Swift River Energy Limited

Environmental Screening/
Review Report -
Addendum

North Bala Small Hydro Project

327078.201.02
Rev. 3
June 2012

Figure 2.1

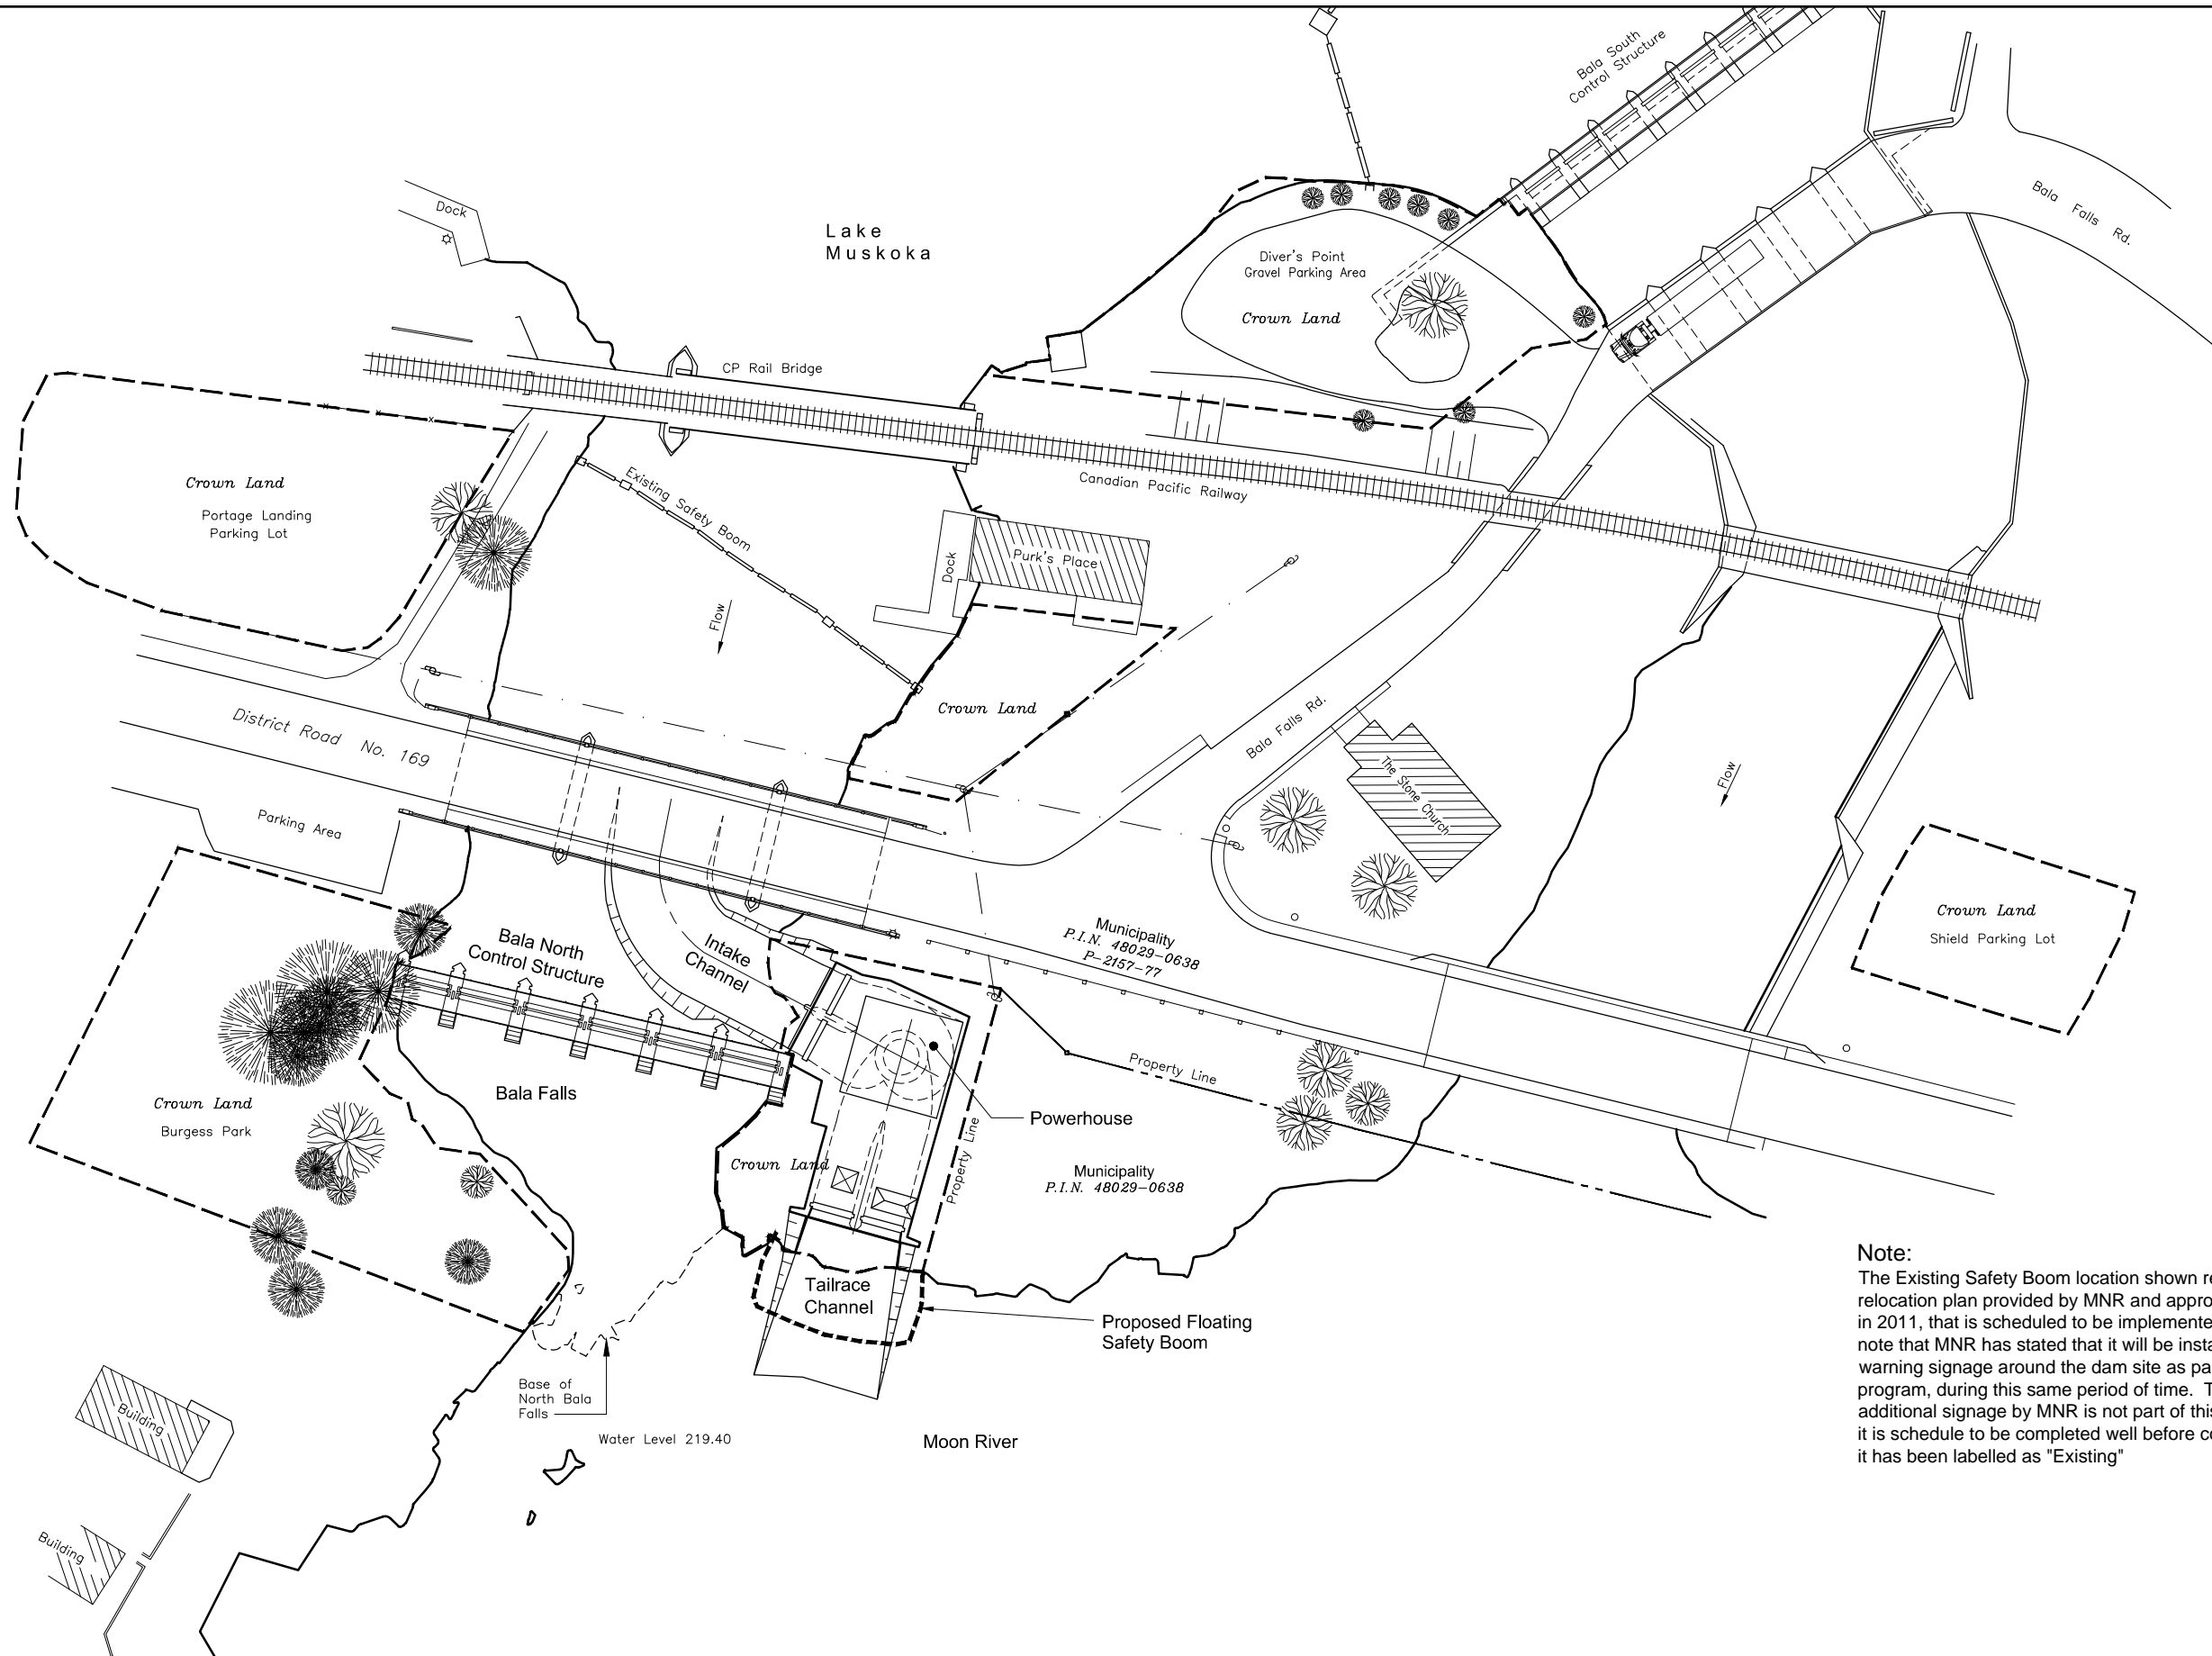
The facility will be located immediately south of the existing North Bala Dam, approximately 25 m north of the Alternative 2D location proposed in the original ES/RR (see Figure 2.1 for the proposed new layout for Alternative 1A). Similar to the originally proposed facility, the development will require the excavation of an approach channel, the installation of an intake leading to a powerhouse and a tailrace returning water to the Moon River immediately downstream of the dam (Figure 2.1). The arrangement of the proposed development is based on a gross head of approximately 6.2 m (as per the ES/RR option), which is provided by the existing dam at the site.

Figure 2.1 displays the general layout of Alternative 1A. The general layout of Alternative 2D, as identified in the ES/RR, is provided in Appendix B. The components of the development are described in the following subsections.

Figure 5.3

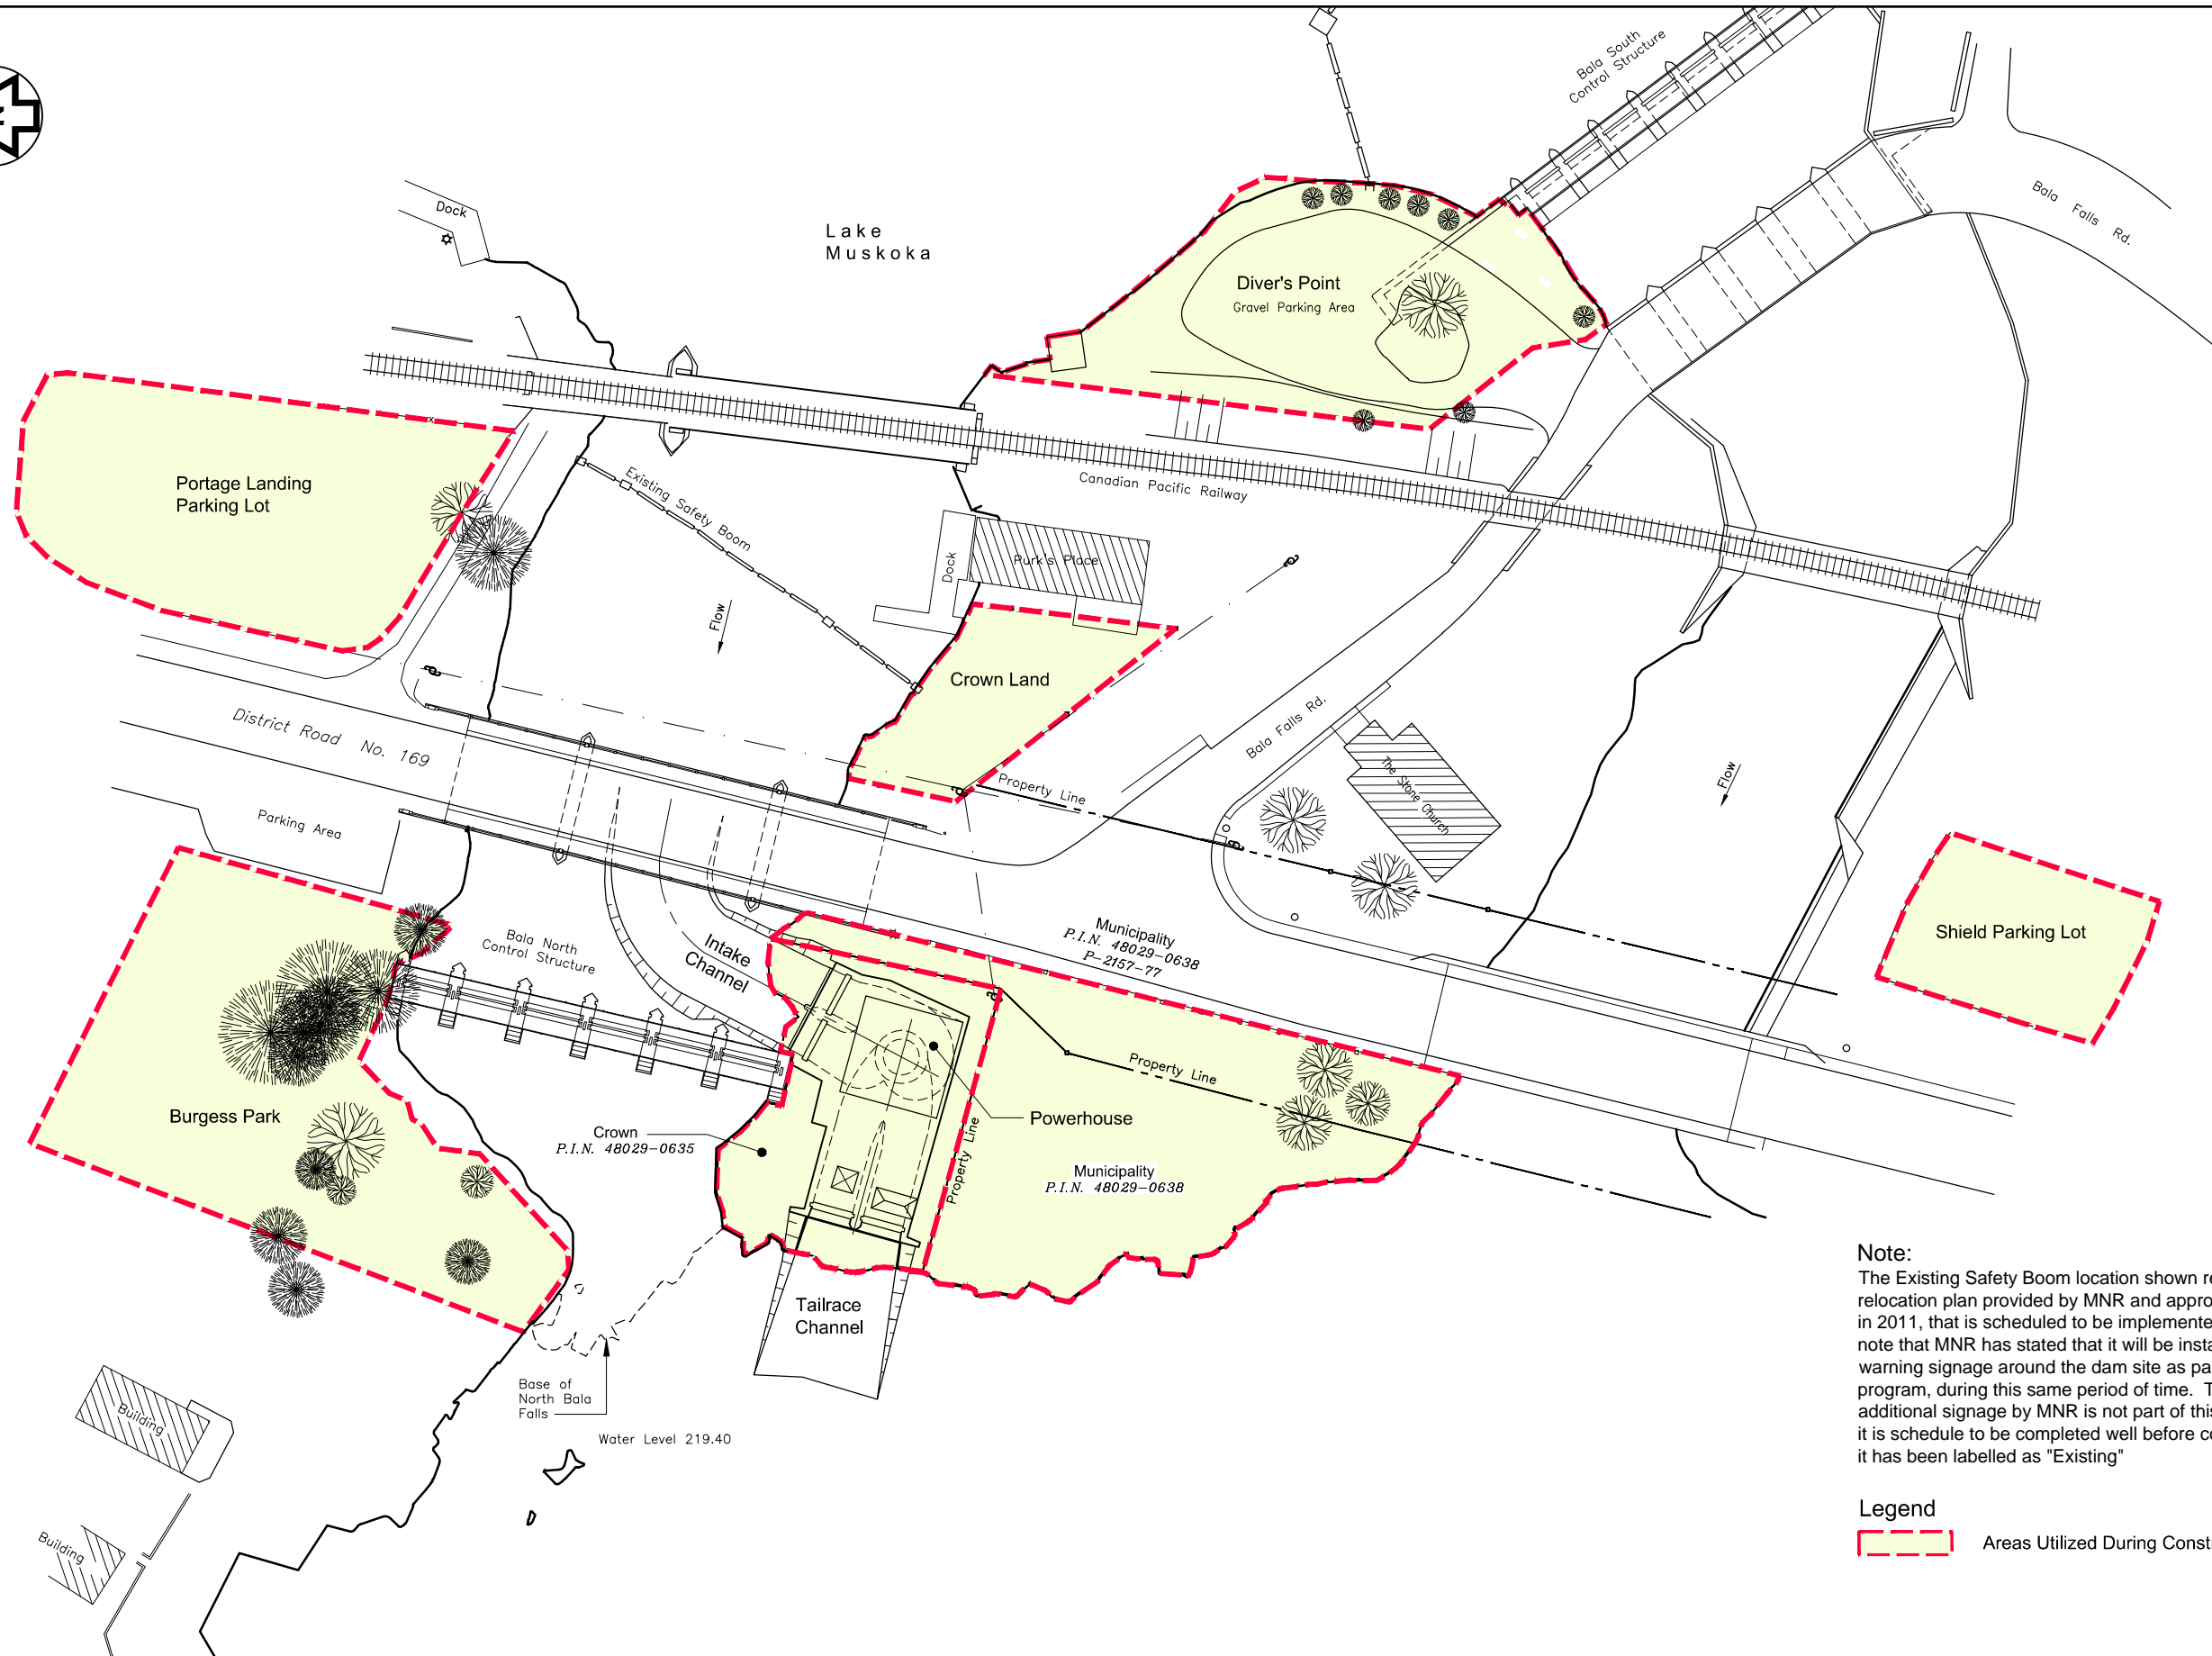
The orientation of Alternative 1A compared to Alternative 2D is approximately 20 degrees farther to the north (see Figure 5.3). This will result in the main flow path being more closely aligned with the main flow direction in Bala Reach, although this is a deep water section with relatively slow flows. No adverse effects on aquatic habitat are predicted from this altered flow path. The altered flow path is not anticipated to have any adverse effects on existing walleye spawning areas at the base of the North Bala Dam and outflow channel from the South Bala Dam, including those areas created by the Community Fisheries Involvement Program. In addition, as discussed in Section 6.2.1, the proposed change in tailrace location and the modified operational regime will not affect the original DFO Letter of Intent commitment to provide 9.5 m³/s of flow over the North Bala Dam during the walleye spawning period.
